Staff Report

Land Division (Tentative Subdivision Plat)

SD-07-19

A NEW 6 LOT SUBDIVISION
3171 GRAND PRAIRIE RD., SE
ALBANY, OR
TITLE SHEET

STA: 0+00.00 TO STA: 1+56.17
ASPHALT CONCRETE ALTERNATE
ISSAC STREET
EXTENSION PLAN

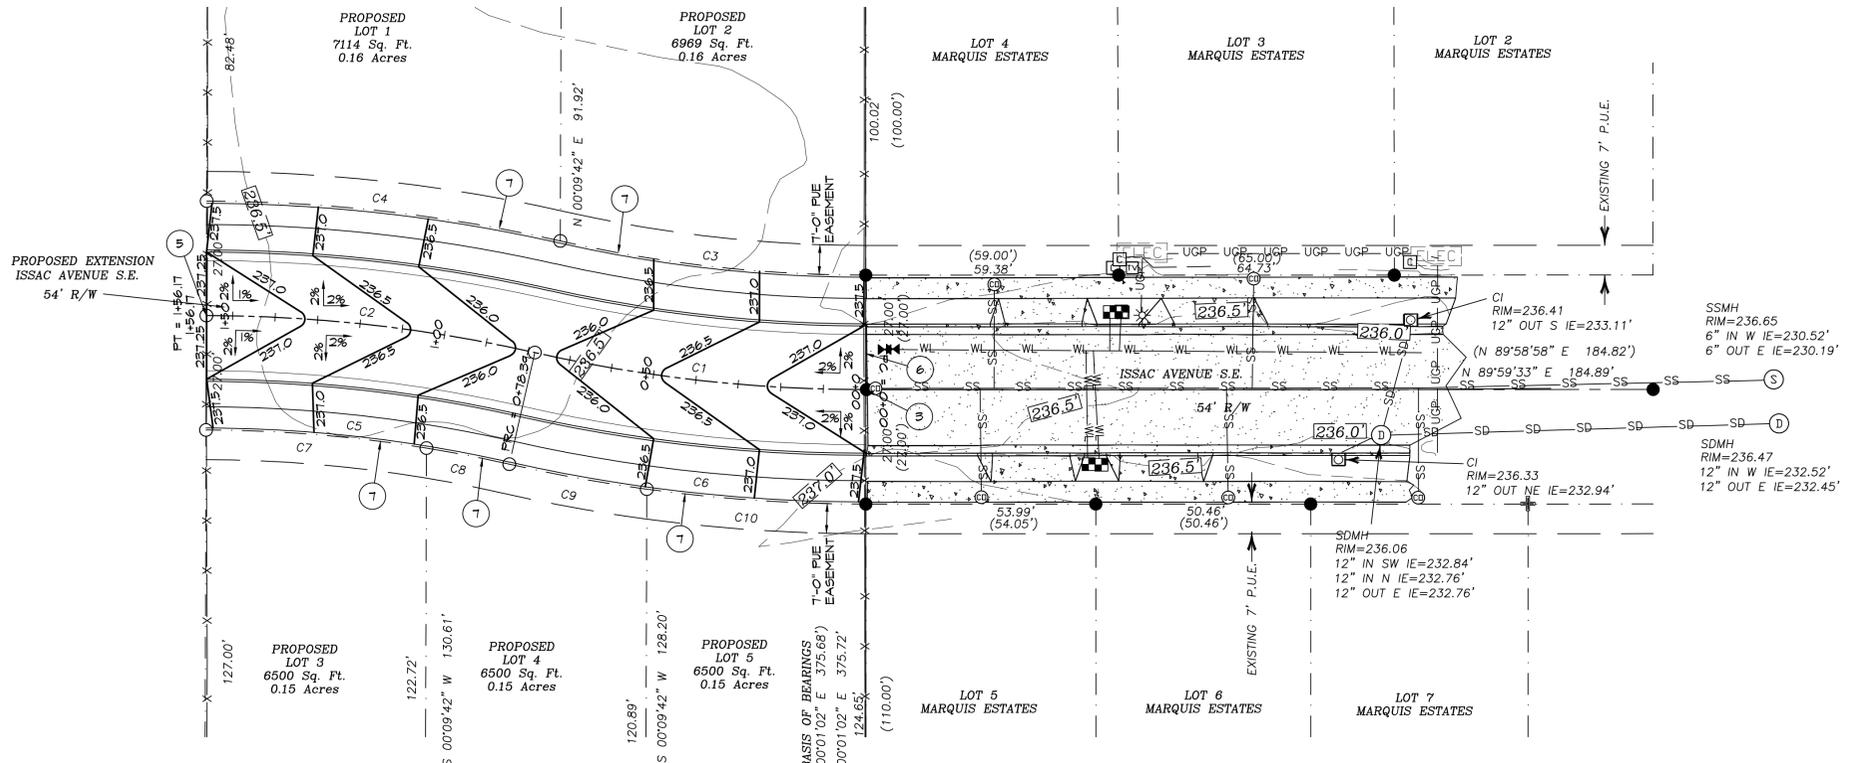
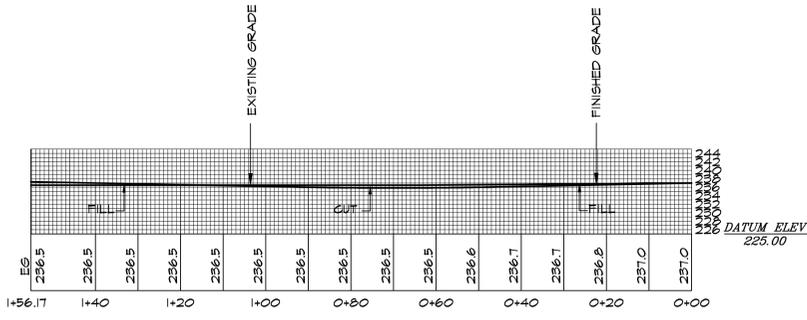
- 4.8 The street plan submitted by the applicant proposes the extension of Isaac Avenue into the site to provide access to Lots 1 through 5. The proposed right of way width is 54 feet and the curb to curb width would be 30 feet. That design complies with the local street design standards contained in ADC 12.122. The existing home on Lot 6 would continue to use an existing driveway approach to Grand Prairie Road. Albany's Transportation System Plan (TSP) does not identify any capacity or safety issues occurring along the street frontages of this development.

**STA: 0+00.00 TO STA: 1+86.22
STORM DRAIN LINE
ISSAC STREET
EXTENSION PLAN**

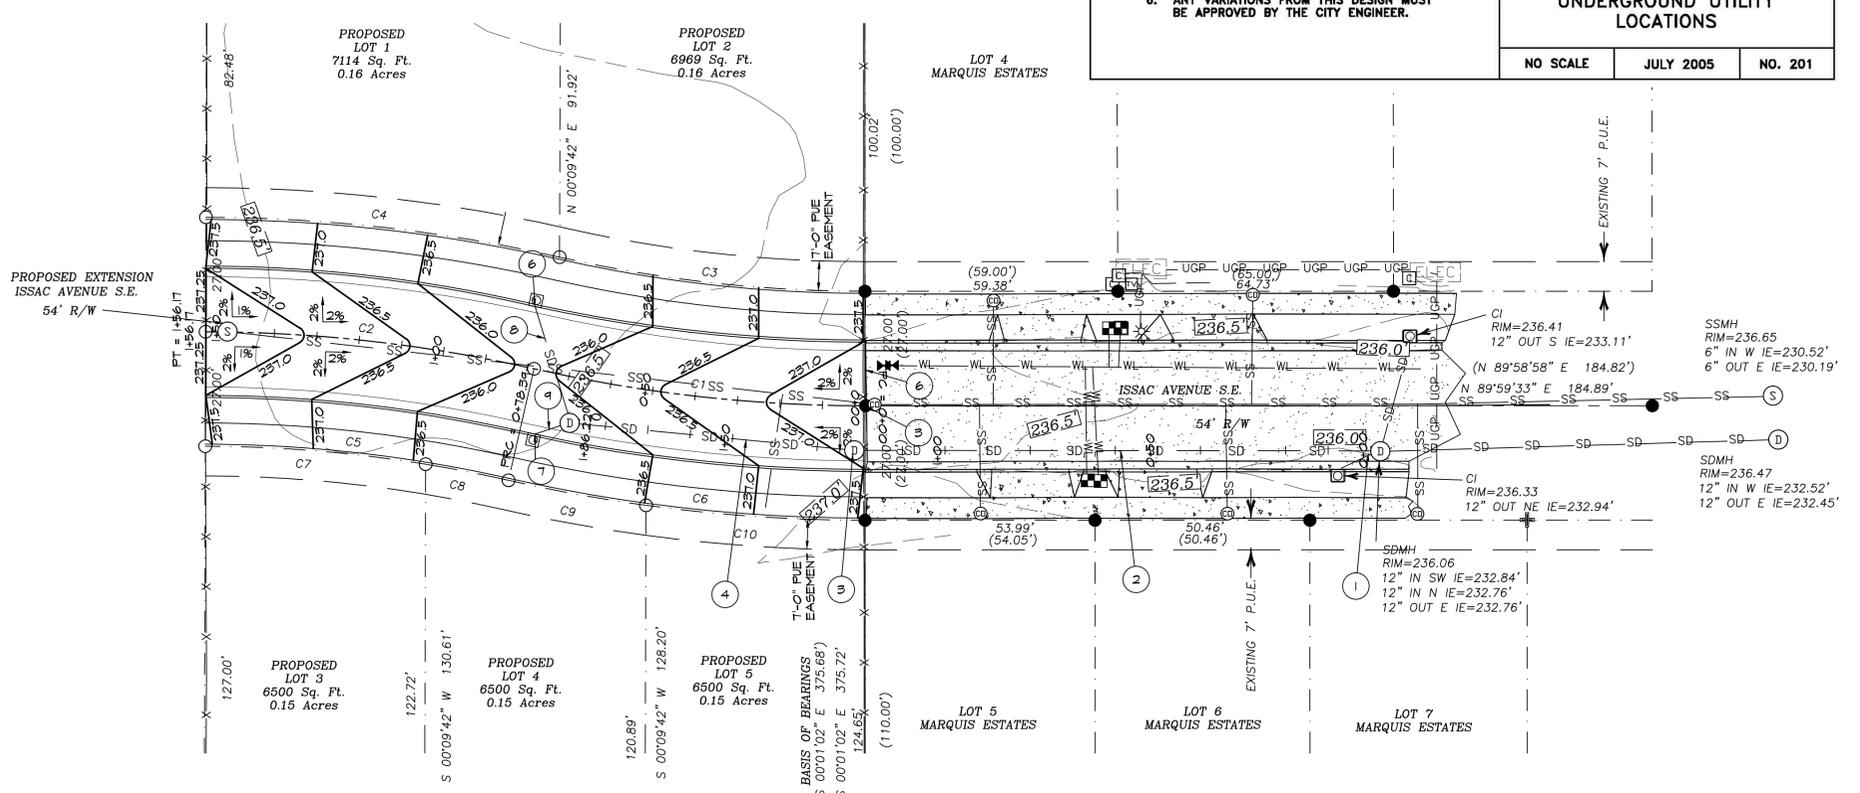
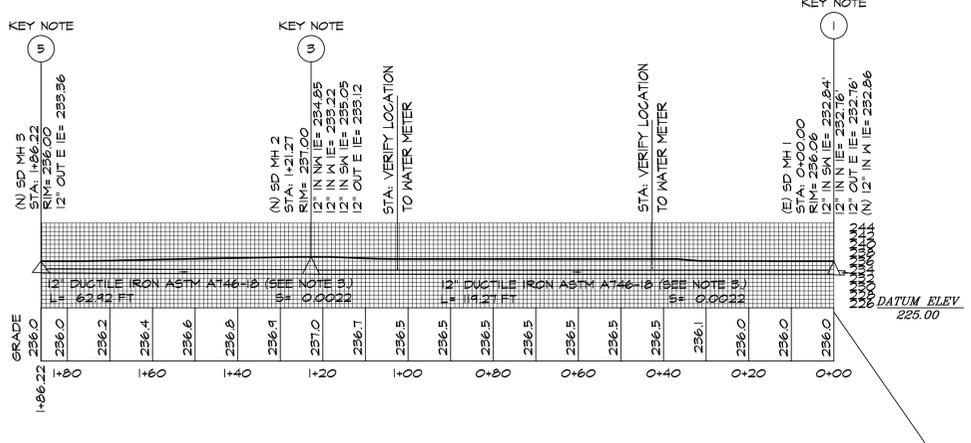
- 5.20 ADC 12.580 states that all new development within the City must, where appropriate, provide for the extension of existing storm sewer lines or drainageways serving surrounding areas. Extensions may be required along all frontages and/or through the interior of a property to be developed where the City Engineer determines that the extension is needed to provide service to upstream properties. In cases where the City Engineer determines that public storm drainage improvements are not timely, the applicant may sign a petition for improvements and waiver of remonstrance in lieu of constructing the required improvements.

- 5.21 ADC 12.550 states that any public drainage facility proposed for a development must be designed large enough to accommodate the maximum potential run-off from its entire upstream drainage area, whether inside or outside of the development, as specified in the City's storm drainage facility plan or separate storm drainage studies.

- 5.22 The applicant's preliminary utility plan shows the extension of the public storm drainage main from the existing main in Isaac Avenue to collect stormwater runoff from the proposed street extension and adjacent lots. The plan appears to be generally acceptable, but final design details will be reviewed in conjunction with the required site improvement permit for public improvements.

Condition 3 Before the final plat will be approved by the City, the applicant must construct public sanitary sewer, water, and storm drainage facilities to serve the proposed subdivision, generally as shown on the preliminary utility plans. A Permit for Private Construction of Public Improvements must be obtained through the City's Public Works Department before beginning work.

A NEW 6 LOT SUBDIVISION
3171 GRAND PRAIRIE RD., SE
ALBANY, OR
POST-DEVELOPMENT STORMWATER SITE PLAN

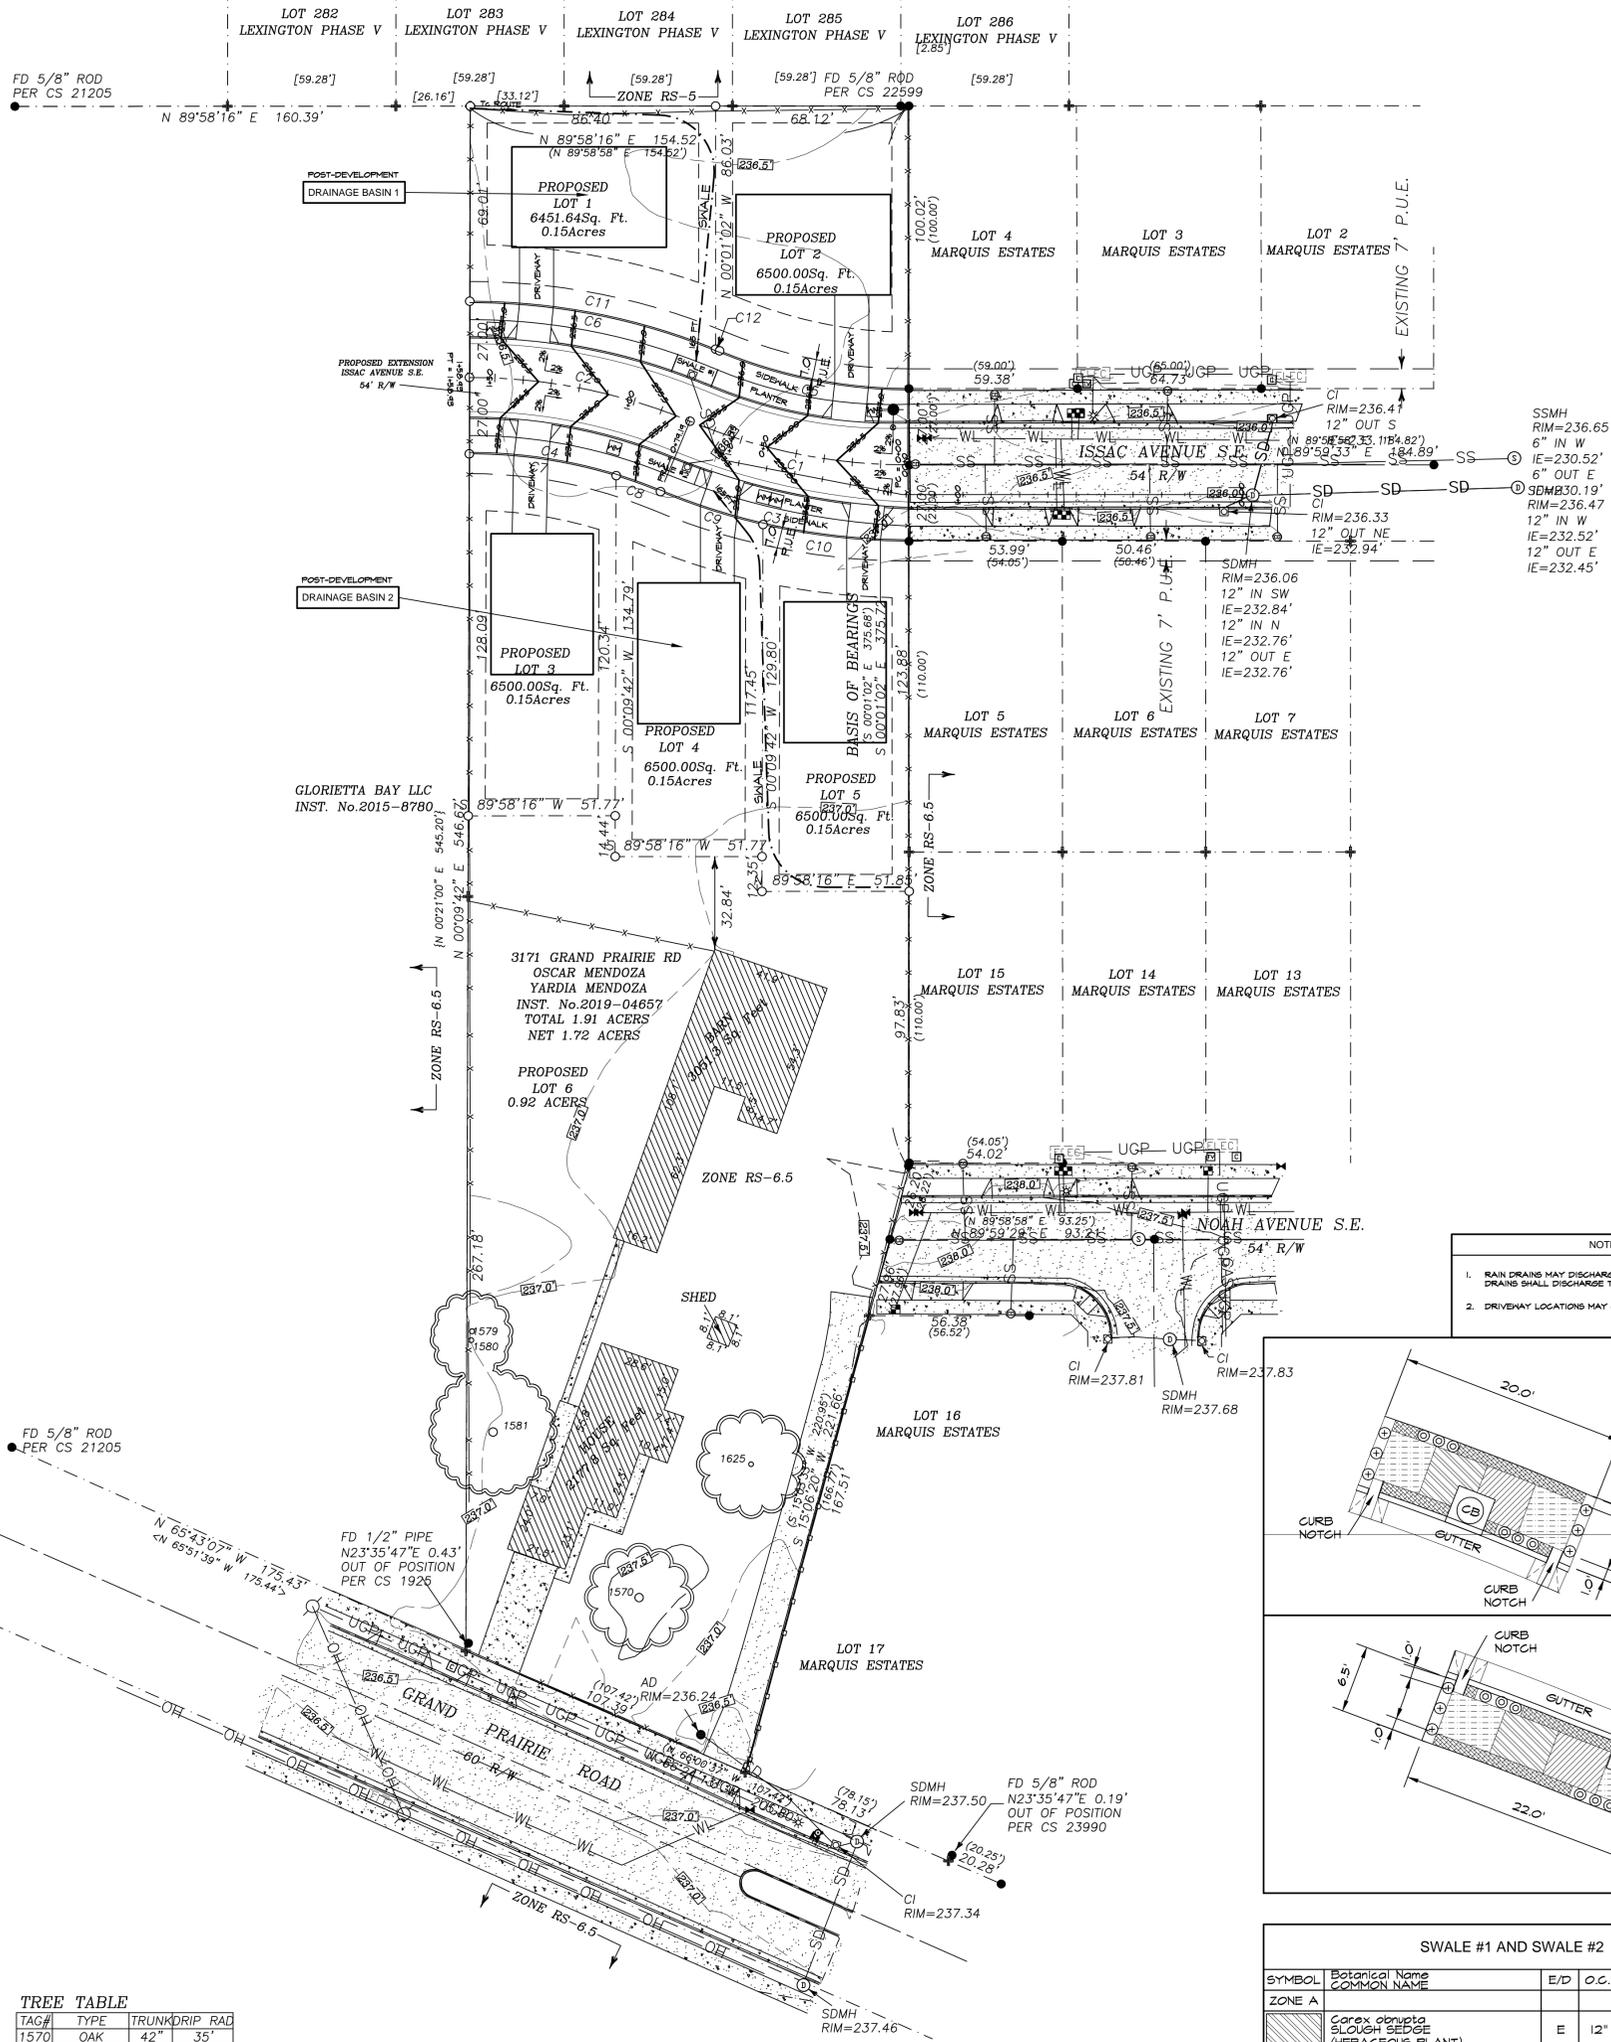
- 5.27 The applicant's preliminary stormwater quality plan indicates that vegetated stormwater quality facilities will be placed in the street landscape strips in conjunction with the required extension of Isaac Avenue. The area needed for treatment will be based on the number of lots proposed and the actual area of impervious surfaces associated with the street construction. Final design details will be reviewed in conjunction with the required stormwater quality permit and/or site improvement permit.

- 5.6 The applicant must provide stormwater quality facilities for the proposed development in accordance with City codes and standards. The final design details will be reviewed in conjunction with the required stormwater quality permit and/or site improvement permit.

STA: 0+00.00 TO STA: 1+49.20
SANITARY SEWER LINE
ISSAC STREET
EXTENSION PLAN

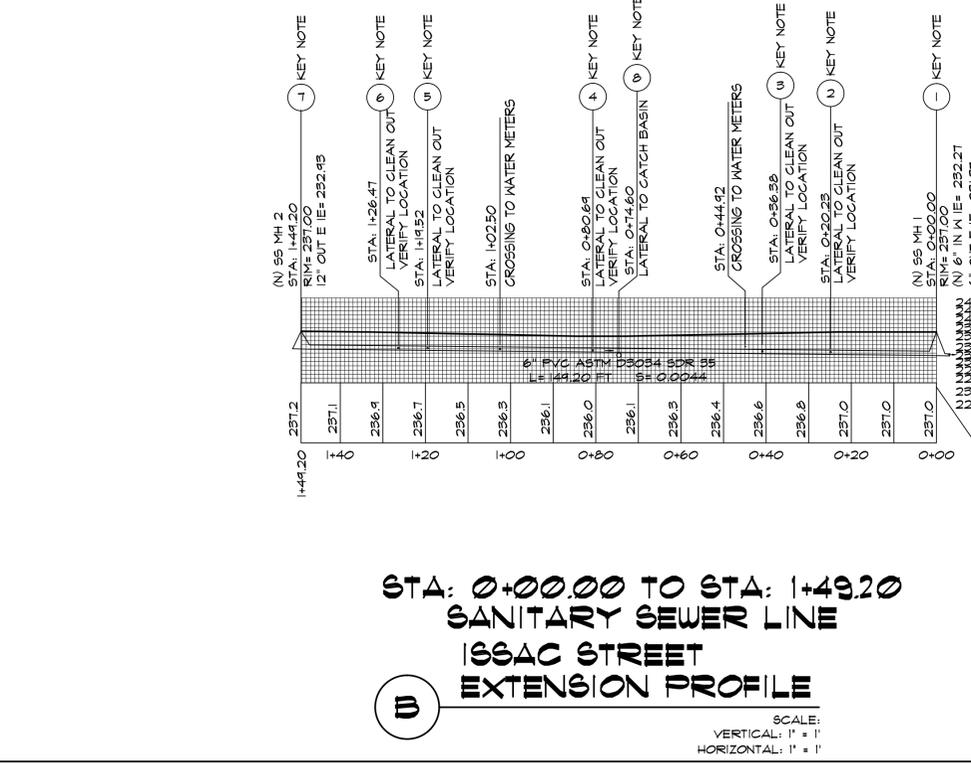
- 5.6 The applicant's preliminary utility plan shows the extension of an eight-inch public sanitary sewer main in the required Isaac Avenue street extension. This public sewer main must be extended to the subject property's west boundary in Isaac Avenue, and service laterals installed to each of the proposed lots.

STA: 0+00.00 TO STA: 1+54.20
WATER MAIN LINE
ISSAC STREET
EXTENSION PLAN

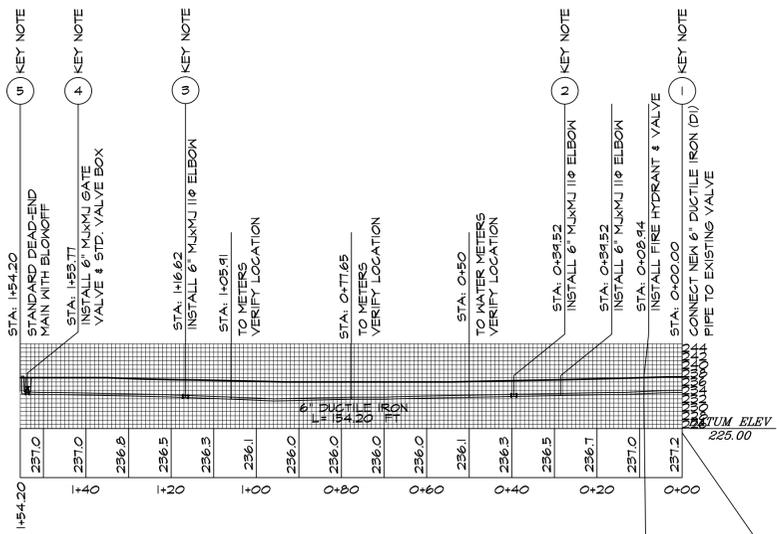
- 5.10 AMC 11.01.120 (2)(e) states that all required public water main extensions must extend to the furthest property line(s) of the development or parcel. Main extensions may be required through the interior of a property to be developed where the City Engineer determines that the extension is needed to provide current or future looping of water mains, or to provide current or future service to adjacent properties. When the owner of a property is required to connect to the public water system, the water main must be extended across the property's entire frontage and/or through the interior of the property. Extension of the water across the property's frontage and through the interior of the property makes the system available to adjacent properties. Then, when the adjoining property connects, that property owner must extend the water mains in a similar manner, making the water available to the next properties. In this way, each property owner shares proportionately in the cost of extending water mains.

- 5.12 AMC 11.01.120 (2)(h) states that all public main extensions must include fire hydrants and other appurtenances in a manner consistent with the recommendations of the water system facility plan, the Standard Construction Specifications, and/or the fire marshal.

- 5.15 The applicant's preliminary utility plan shows the extension of an eight-inch public water main in the required Isaac Avenue street extension. This public water main must be extended to the subject property's west boundary in Isaac Avenue and services installed to each of the proposed lots.
